EVALUATION OF 30 KW AND 2.5 KW
GENERATORS USED ON SERVPAC
ARS AND ATF CLASS SHIPS

November 1974

Prepared for
PERA(CSS)
Hunters Point Naval Shipyard
San Francisco, Calif.
Under Contract N00604-74-C-0234

Publication 1620-01-2-1338

Figure 3. Recommended System Design Schematic (Elementary)

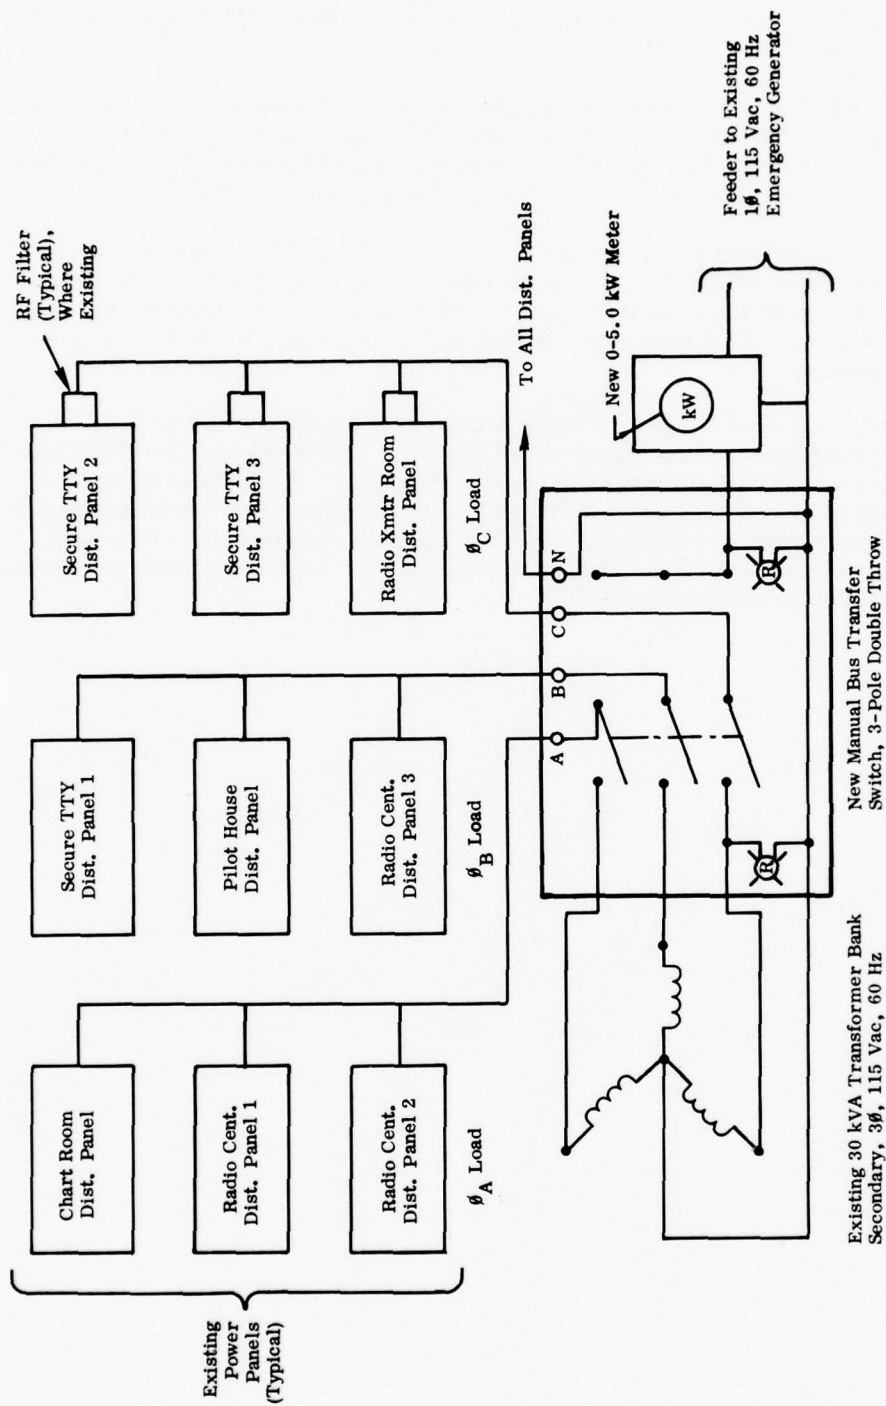
- b. Provide a manual bus transfer switch of the type having power-source lamp indicators which, when lit, would indicate power availability.
- c. Provide, in the vicinity of the power transfer switch, a panel-mounted, single-phase kilowatt meter scaled 0 to 5.0 kW, or a similar type ammeter scaled 0 to 30 ac amperes. The meter would be redlined at a value appropriate to the emergency generator rating, wired into the emergency power circuit, and labeled "Emergency Generator Output".

- d. Remove the emergency power transfer capability now existing in each ship and restore any power panel so serviced to a sole-power-source configuration served via the new transfer switch. In those instances where equipment is provided emergency power directly from the emergency generator and uses a built-in power selection switch, remove the emergency power cable connections at the serviced equipment.

- e. Provide, as a minimum, a manual remote start capability for the emergency diesel generator in the vicinity of the new bus transfer switch to obviate the need for personnel to leave the ship's weather-tight enclosure for equipment light-off. This capability, with automatic start, is incorporated into at least one of the new 3.0 kW generator installations being provided by Shipalt ARS-310D as part of the Onan Corporation-supplied control cabinet; however, no similar shipalt is known to exist for the ATF classes.

30 KW DC/60 HZ MOTOR GENERATOR SET
MODIFICATION TO VOLT & SPEED
REGULATOR INPUT POWER

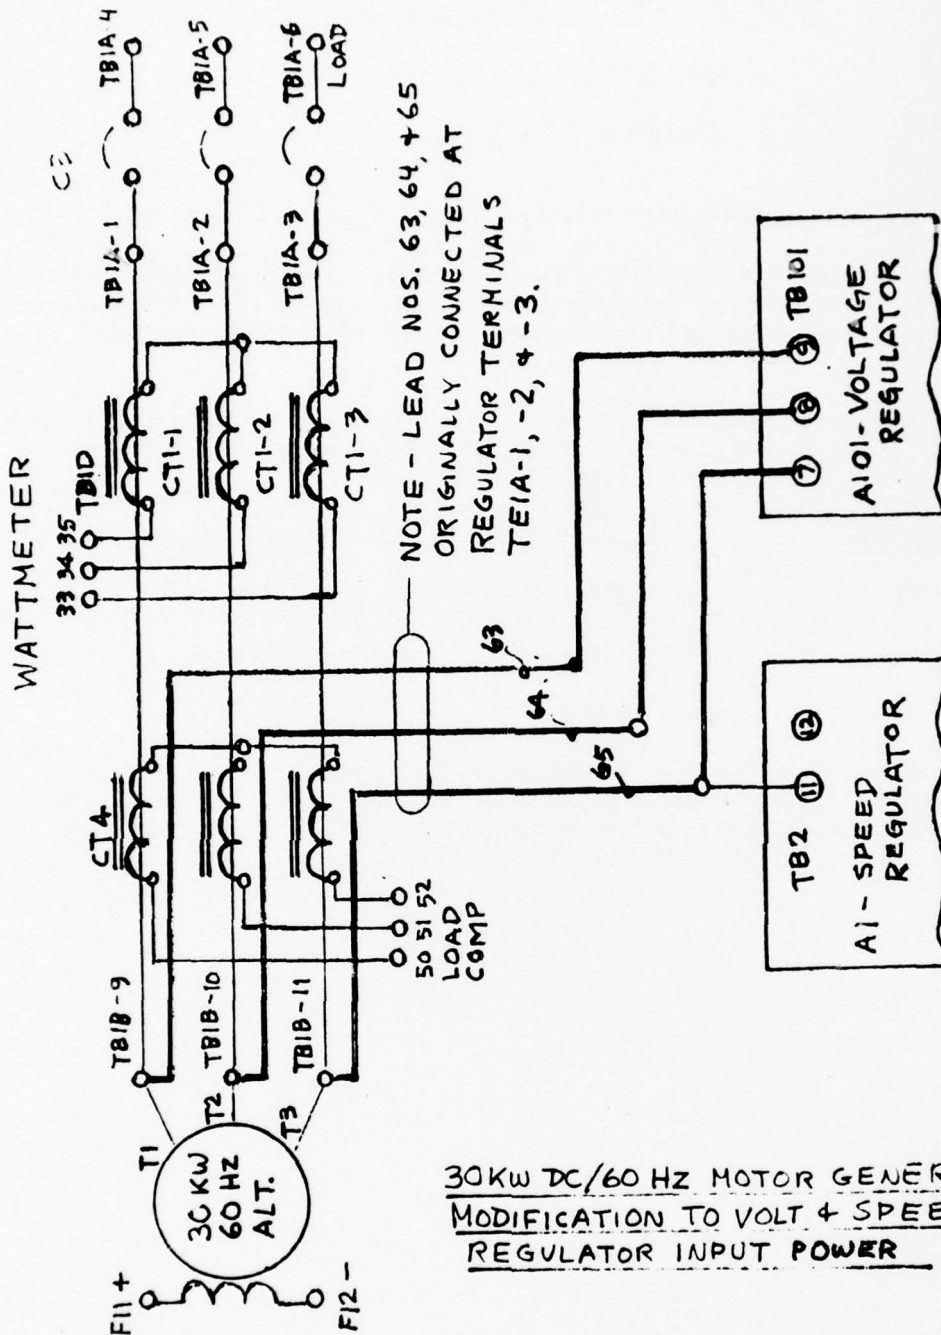
1. In the event of a shorted transformer (T101) secondary circuit, a high current is reflected in the transformer primary circuit. Current transformer (CT4) senses this current level increase and supplies the alternator field excitation to sustain the current flow.
2. To eliminate this condition and preclude burnout of potential transformer (T101) in the event of a short circuit in its secondary, the following circuit modification should be made:

3. The attached sketch reflects the circuit modification which connects the regulator potential transformer leads to the generator side of current transformer (CT4). This action prevents the current transformers from supplying generator field excitation when a regulator short circuit develops.

<u>Lead Nr.</u>	<u>Original Term.</u>	<u>New Term.</u>
63	TB1A-1	TB1B-9
64	TB1A-2	TB1B-10
65	TB1A-3	TB1B-11

FIGURE 1.

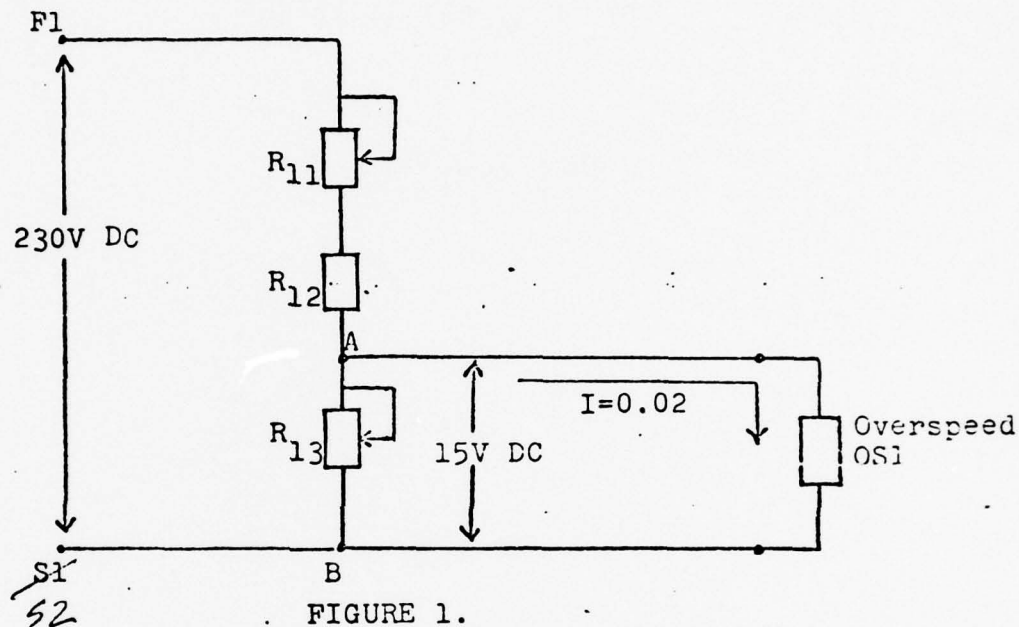
These resistors have incorrect value and power rating.

- b. Replace R13 with 20 ohm, adjustable resistor as recommended in enclosure (1) except increase the wattage to 60 watts. The higher wattage rating is necessary since the resistor wattage rating is applicable only when all resistance is in the circuit. The resistor wattage rating must be derated by approximately the same percentage as the reduction in actual resistance.

Figure C-1. Overspeed Circuit of 30 kW Motor Generator Set*

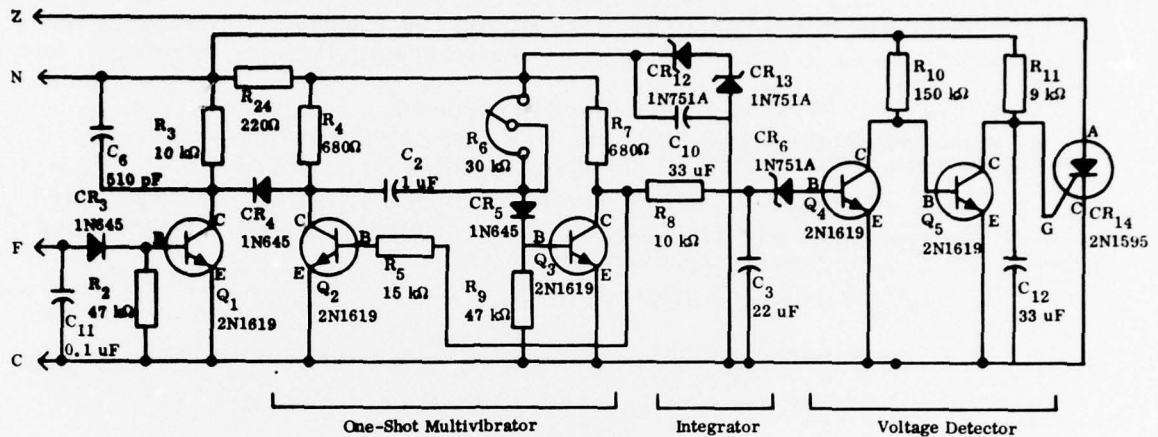
*Figure C-1 reflects a correction that should be made in the circuit given in TM 0962-046-0010. Capacitor C12 should be located between Q5 and reference, as shown above; and not between Q4 and reference, as in the TM figure.

The above data indicates a frequency change of 5 Hz for the 25°C variation, which explains why the overspeed circuit actuated at high temperatures. Since nominal frequency is 30 Hz (1800 rpm ÷ 60 = 30 rps), the overspeed circuit sensed an overspeed condition when temperatures exceeded 40°C and therefore actuated the relay to turn off the motor.

To correct the deficiencies noted above, the minimum modifications needed to the overspeed circuit are:

- b. Replace the 150 k Ω collector resistor, R₁₀, with a 1 k Ω resistor RC20GF102K.
- c. Adjust the threshold from the present 10% to 15% over nominal frequency.

Figure C-2. Recommended Modification to Voltage Detector

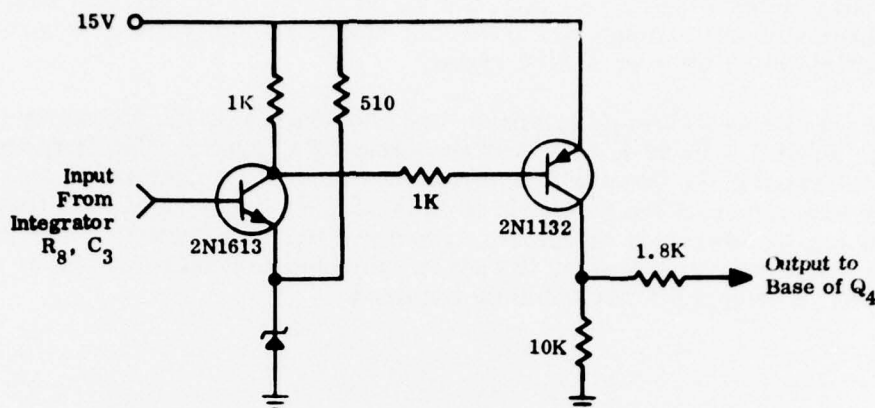
To increase the base drive needed to saturate Q₅, and to bias the zener to operate at a current level close to its knee, it is recommended that R₁₀ (150 kΩ) be replaced with a resistor of lower value, say 1 kΩ.

A "complete" fix of the overspeed circuit problem would be to accomplish the above modifications and to add the circuit shown in Figure C-2. Addition of that circuit would require a board redesign, but would result (in conjunction with the above-recommended modifications) in a frequency stability, confirmed in laboratory testing, of approximately 2 Hz over a 25°C range.

as effective – would be to substitute a 1 k Ω resistor for the present 150 k Ω resistor at R₁₀, as described previously. The alternative modification would not provide as stable a circuit as the initially suggested one, but would reduce the reference problem.
